# Sunrise 3 Hardware Reference Design Errata

Rev. 0.4

July 12, 2021

This document describes the potential problems found during the verification of the Sunrise 3 DVB. The documents is applicable to the following Sunrise 3 DVB schematic and PCB layout revision.

Figure 2-1 Sunrise 3 integrated ESD protection

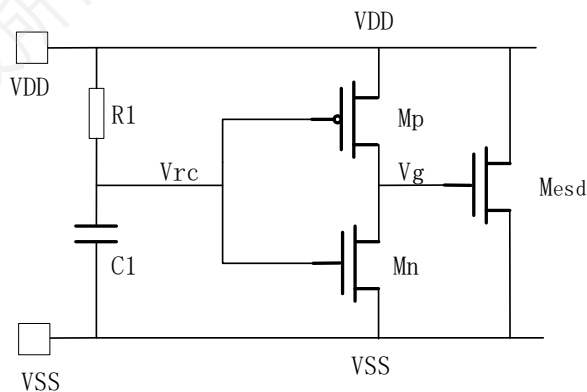
Some of the Power rails of Sunrise 3 integrate a typical ESD protection circuit depicted by the following figure.

When VDD ramp up too fast (ESD transient), the RC delay circuit will keep Vrc low and Vg high, then Mesd will be opened to sink the ESD transient to VSS.

However, if normal power up event has too fast ramp up rate, it will mis-trigger the Mesd and has the very small potential to damage the Mesd after numerous power-up events.

Regarding the Sunrise 3 reference design, the failed power rail is VAA and PVT\_VDDA\_TAVDD. The actual measured ramp up rate is around 25mV/us.

Figure 2-2 DDR PHY VAA ramp up rate control circuit

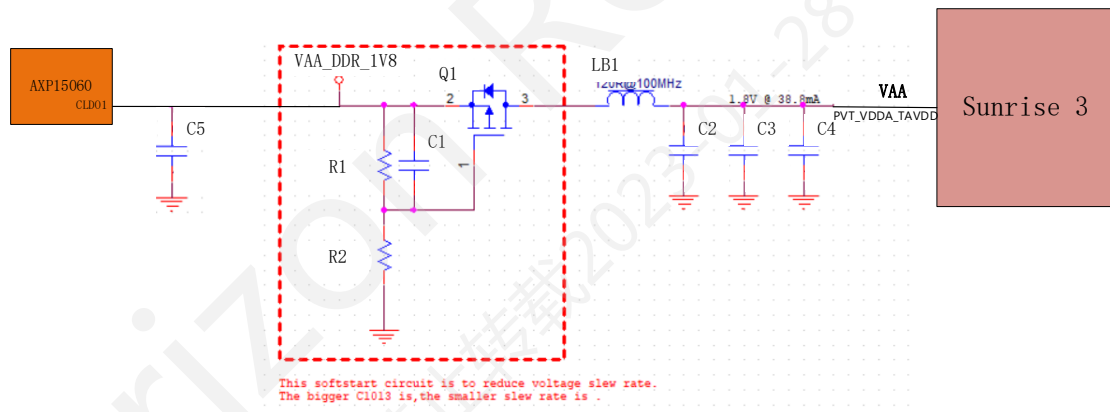
- One option is to use a discrete LDO power supply which has < 5mV/us ramp up rate.
- The 2<sup>nd</sup> option is to use the following soft start circuit between the LDO output and VAA.

1. select Q1 with small  $R_{ds(on)}$  ( $< 200m\Omega$ ) and continuous  $I_d$  drain current  $> 200mA$
2. Make sure voltage feed into VAA still meets the ripple requirement ( $1.8V \pm 2.5\%$ )
3. Adjust the value of C1 to achieve  $< 5mV/\mu s$  ramp up rate.

Figure 2-3 External POR reset circuit

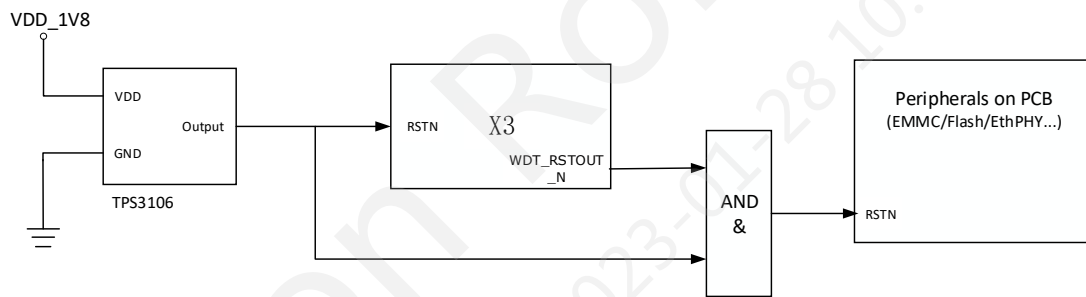
Sunrise 3 needs external Power-On-Reset (POR) input through RSTN pin to reset the entire chip. The RSTN should be stable more than 10ms after all the power groups (1/2/3/4) achieve target value and 24MHz main clock is active and stable.

Figure 2-3 shows the recommended connection of external POR circuit.

**Note:** WDT\_RSTOUT\_N signal needs to be sent to peripherals on the board especially memory devices (EMMC and Flash) and can't be sent back to X3's RSTN input signal via PCB trace.

Figure 2-4 CNN Power supply transient voltage drop

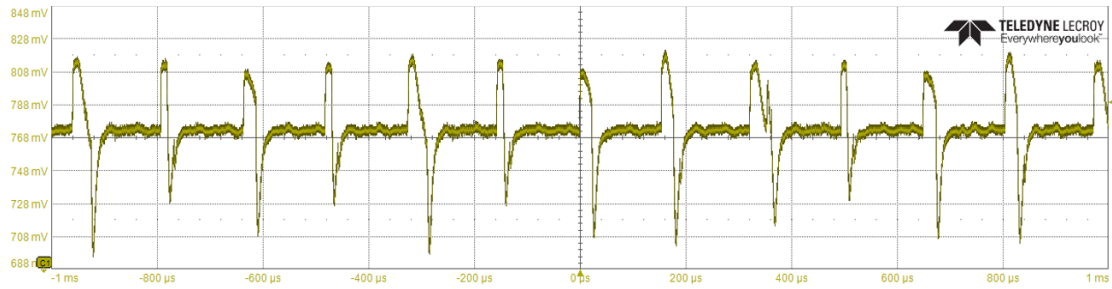
Because Sunrise3's CNN behavior causes much higher  $di/dt$  (current variation over time) than other core power supply, the power supply to CNN core needs to have better transient load response performance. Otherwise, transient voltage drop will occur on VRM's output. Please check the following figure for this phenomenon.

- ◆ First way is to choose a DCDC/PMIC with better transient load response performance, the following table depicts a reference requirement for DCDC/PMIC transient load response.

- ◆ 2<sup>nd</sup> way is to increase Cout to BIGGER value if the PCB space could accommodate the extra component. The following table gives some reference part number which could be used. Customer could choose their own part number with enough capacitance and small ESR.

**NOTE:** Balance the DCDC/PMIC selection and Bulk capacitor selection to achieve the result depicted by following table. Be noted that the measurement should be done under customer typical scenario with BPU in maximum loading.

Figure 2-5 VBUS Insertion Detection Solution

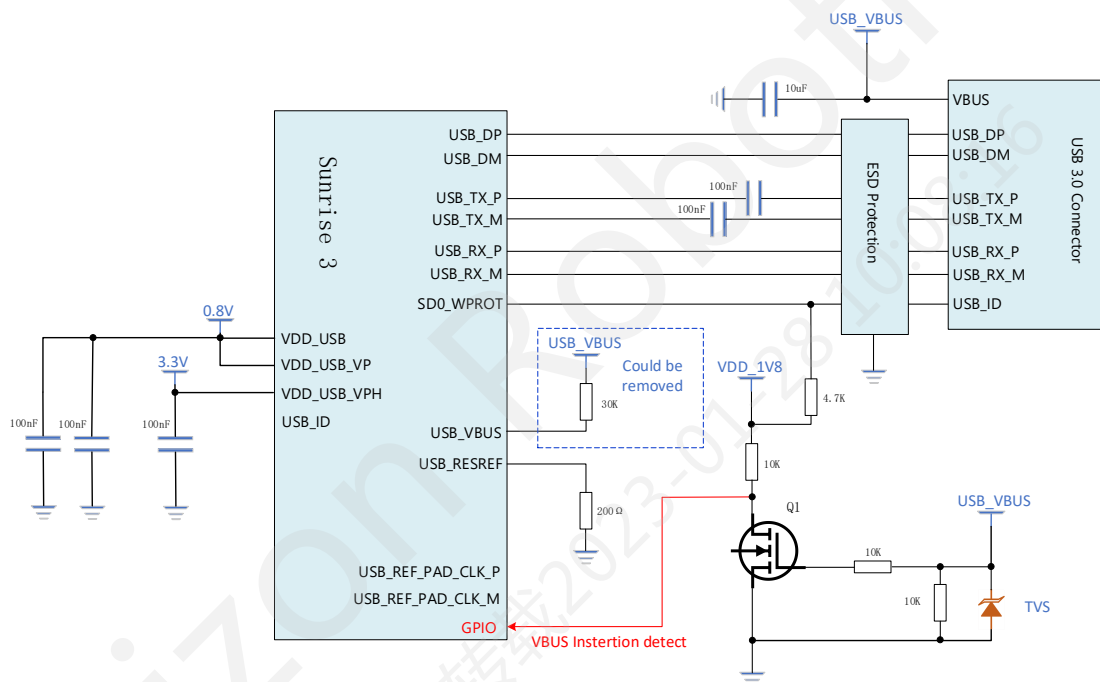
USB\_VBUS pin is not functional available at the package ball. The  $30K\ \Omega$  pull up resistor is no longer needed, and the VBUS detection is also not available through USB\_VBUS pin.

**Solution A:** use a separate GPIO to detect the VBUS insertion. Please refer to the Figure 2-5 for the detail connection. Dedicated software thread is needed for GPIO status polling.

Figure 2-7 EFUSE VDD Connection

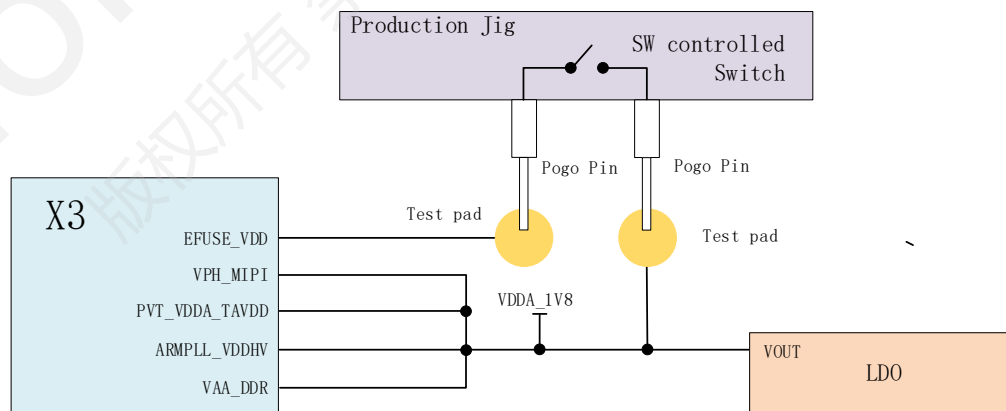
EFUSE\_VDD is default powered up by 1.8V LDO output. EFUSE\_VDD needs only to be powered up while burning X3 EFUSE, and it should be connected to ground or left floating in all other situation except burning EFUSE. Otherwise, there is very small chance that the EFUSE content is mistakenly changed.

Connect EFUSE\_VDD to the test pad instead of 1.8V.

EFUSE\_VDD will be floating in customer normal scenario. When customer needs to change the content of EFUSE in production line, use production jig to short the EFUSE\_VDD to 1.8V.

Figure 2-8 EFUSE\_VDD on/off Sequence

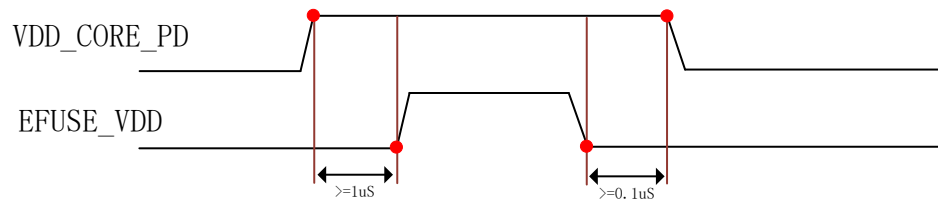
The short behavior needs to be controlled by SW to make sure that the EFUSE\_VDD on/off sequence describe in Figure 2-8 is fulfilled.
